PRODUCT/PROCESS CHANGE NOTIFICATION

PCN MMS-MIC/14/8385
Dated 10 Jul 2014

UFBGA Transfer back-end site from Amkor ATK (Korea) to Amkor ATP (Philippines) & Features improvement for STM32F42xIxH & STM32F43xIxH products

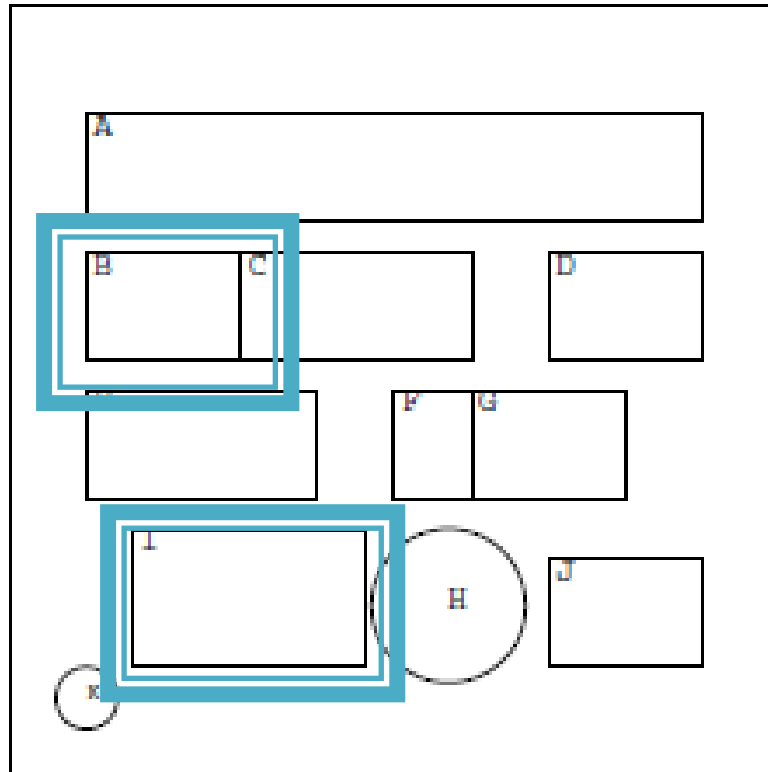
The marking composition indicated on the products is changing:

B : Assy plant
changes from HP to 7B

I : Country Of Origin
changes from KOR to PHL
